DART AEROSPACE LTD	Work Order:	101943
Description: Crosstube Assembly (412 High Aft)	Part Number:	D412-664-243
Inspection Dwg: D412-664-243 Rev: E		Page 1 of 2

D212-664-243
ASSEMBLY DETAIL

DRAWING NO. D412-664-243	TITLE CROSSTUBE ASSEMBLY (412 HI AFT)	REV. E	DART AEROSPACE LTD ENGINEERING ORDER		D.E.O. NO. D412-664-243-E-4	SHEET NO. SHEET 1 OF 3	SCALE NTS
DRAWN 92	CHECKED A	MFG. APPR. A	APPROVED MP		DE APPR. A		
DATE 12.08.21	DATE 12.08.30	DATE 12.08.30	DATE 12/8/30		DATE 12.08-30

REMOVED ABRASION STRIP IN FAVOR OF A THIN LAYER OF PROSEAL 890. UPDATE INSTALLATION OF CHAFING SHIELDS AND REDUCE TORQUE TO 40-50 IN-LBS. THIS ENGINEERING ORDER SUPERCEDES DEO D412-664-243-E-1.

D412-664-243
ASSEMBLY DETAIL

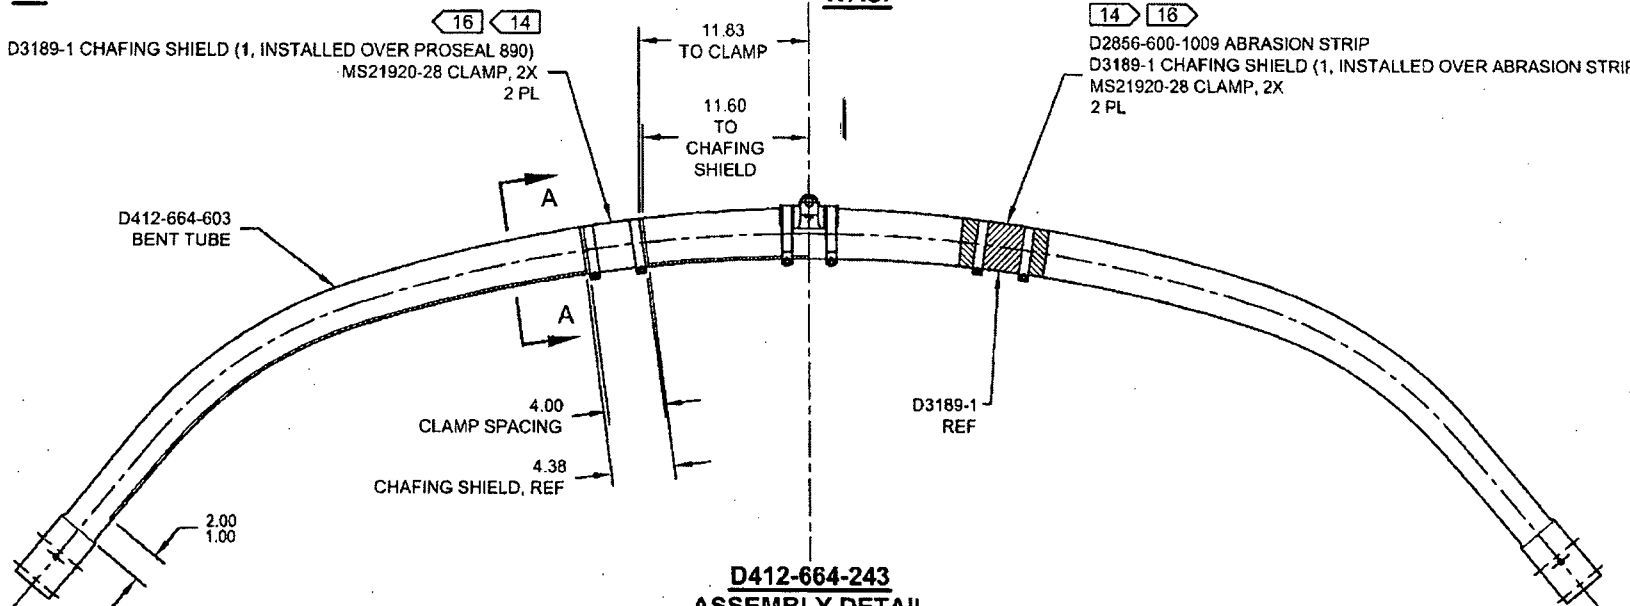
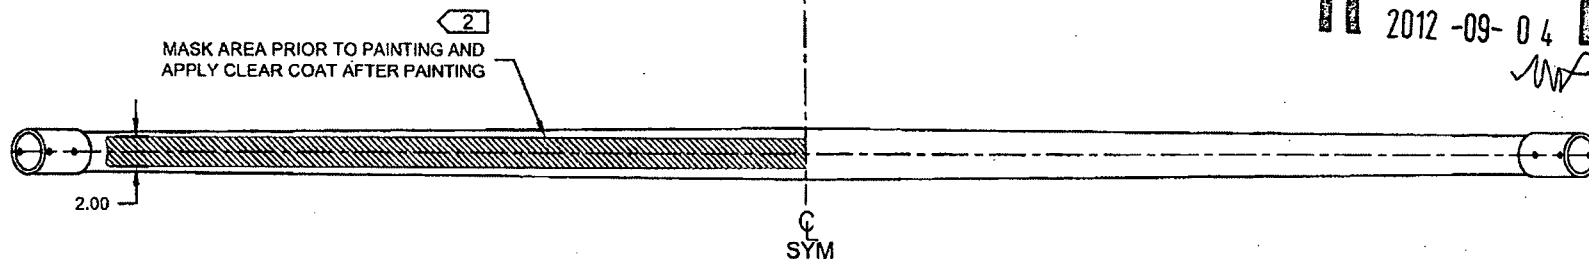
IS:

D3189-1 CHAFING SHIELD (1, INSTALLED OVER PROSEAL 890)
MS21920-28 CLAMP, 2X
2 PL

WAS:

D2866-600-1009 ABRASION STRIP
D3189-1 CHAFING SHIELD (1, INSTALLED OVER ABRASION STRIP)
MS21920-28 CLAMP, 2X
2 PL

SECTION A-A
CHAFING SHIELD DETAIL
VIEW ROTATED, NOT TO SCALE

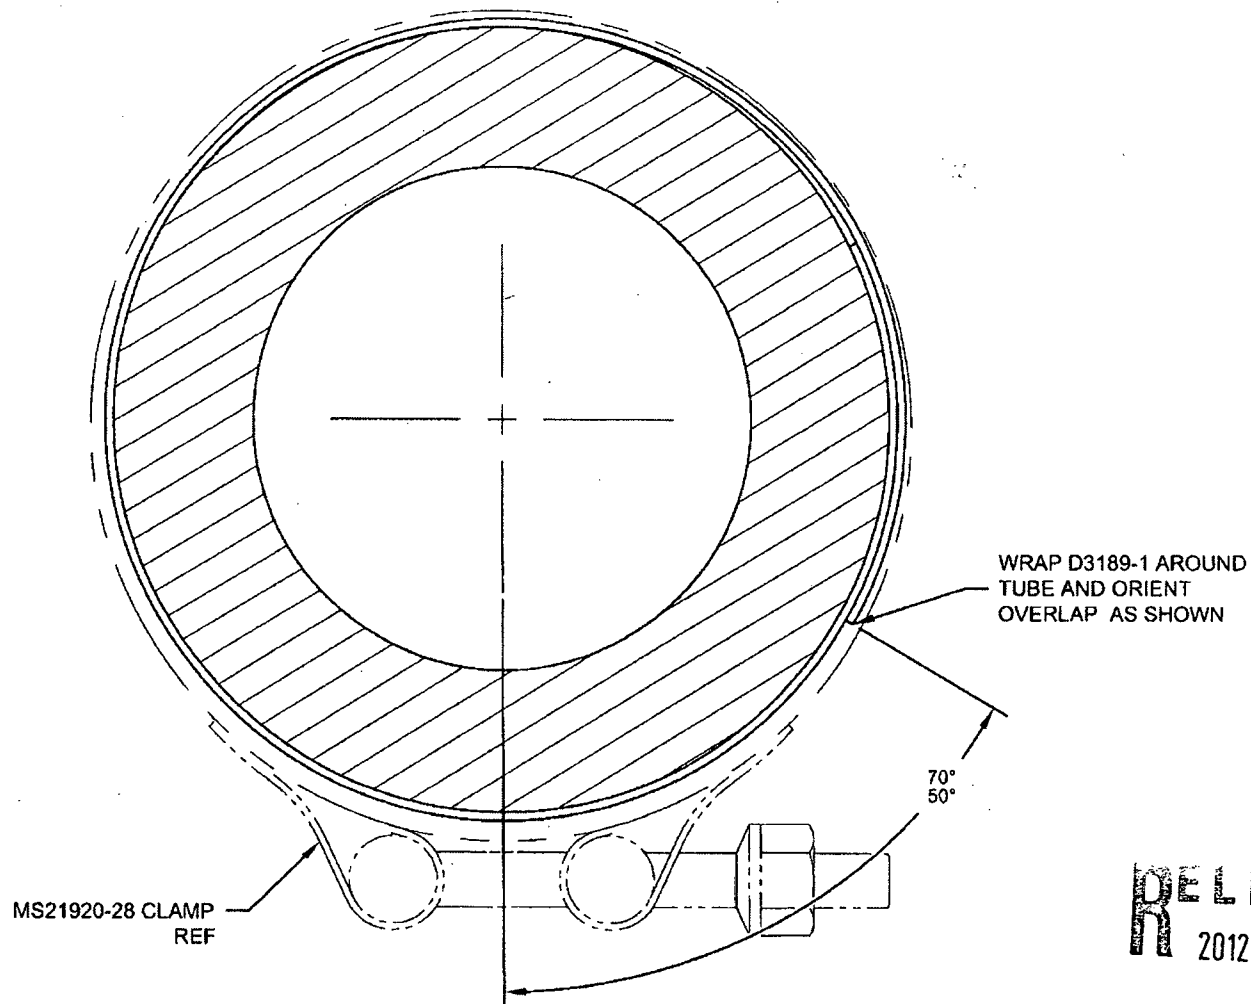
NOTES 2, 14, AND 16 ON SHEET 1 ARE AMENDED AS FOLLOWS:

- 2) FINISH: CHEMICAL CONVERSION COAT PER DART QSI 005 4.1
PRIME INSIDE AND OUTSIDE PER DART QSI 005 4.2
MASK UNDERSIDE OF CROSSTUBE AS SHOWN (HATCHED AREA)
PAINT OUTSIDE PER DART QSI 005 4.2
AFTER PAINTING, APPLY CLEAR COAT ON HATCHED AREA
- 14) APPLY A THIN COAT OF PROSEAL 890 ON INSIDE CONCAVE SURFACE OF D3189-1 CHAFING SHIELD AND LET CURE PER MANUFACTURER'S INSTRUCTIONS. INSTALL PROSEALED D3189-1 CHAFING SHIELD ONTO CROSSTUBE BY APPLYING A THIN COAT OF PROSEAL 890 ONTO CROSSTUBE. BE SURE TO ELIMINATE ANY AIR GAPS.
- 16) TORQUE CLAMPS ON D2896-1 SUPPORT 80 TO 100 IN-LB. **TORQUE CLAMPS ON D3189-1 CHAFING SHIELD 40 TO 50 IN-LB.** ENSURE AT LEAST 1.5 THREADS SHOWING IN SAFETY AND THAT NUT HAS NOT BOTTOMED-OUT AFTER TORQUING.
